8 COMMENTS ON THE DRAFT EIR

Subject: Equestrian Facilities Project
SCH#: 2007051074

SCH# 2007051074
Project Title Equestrian Facilities Project
Lead Agency Parks and Recreation, Department of

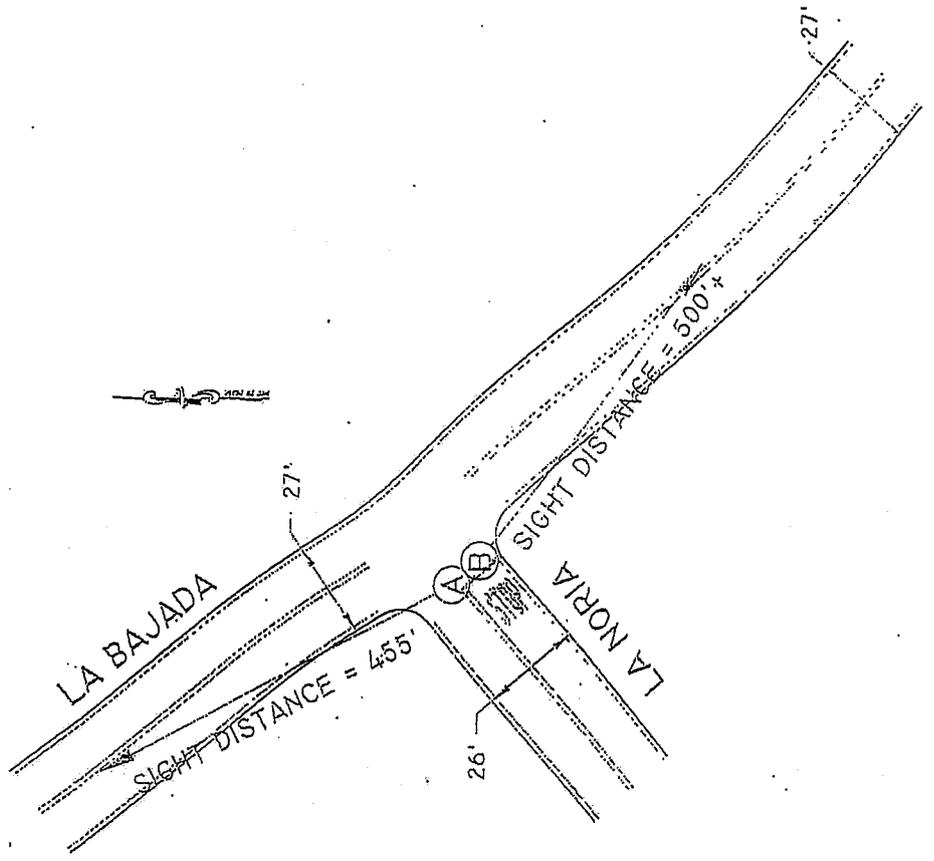
Sight Distance calculations should be submitted with the Traffic Impact Study (TIS) showing that the California Department of Transportation (Caltrans) standards are being met as outlined in the Highway Design Manual (HDM). The sight distance calculations should show all existing and proposed trees etc. These should be signed by a Registered Engineer in the State of California. (See attachment).

NOTES:
 SIGHT DISTANCE WAS MEASURED AT 8' BACK FROM PERCELINE ON LA BAJADA
 POSTED SPEED LIMIT = 40 MPH ON LA BAJADA
 PREVAILING SPEED = 45 MPH ON LA BAJADA

<u>Comment No.</u>	<u>Response</u>
4-1	Sight Distances were calculated and a sight distance report will be provided with the encroachment permit application.
4-2	A truck turning movement analysis was performed and will be provided with the encroachment permit application.
4-3	Comment noted. Although the traffic counts were measured over 2 years ago (August 2008), DPR believes the data are still relevant due to limited development within the rural community of Descanso and no development of user facilities within the Park since 2008.
4-4	Comment noted. Corrected speed limit will be used in all design calculations.
4-5	Comment noted. DPR believes the 20 year build-out scenario is not useful in this situation because very little growth and development is likely to occur in the project locations. 20 year build-outs are useful in more urban areas of the County that are experiencing rapid growth.
4-6	The Traffic Count Data sheets for SR-79/Riverside Drive northbound and southbound are included in Appendix B of the Traffic Impact Study.
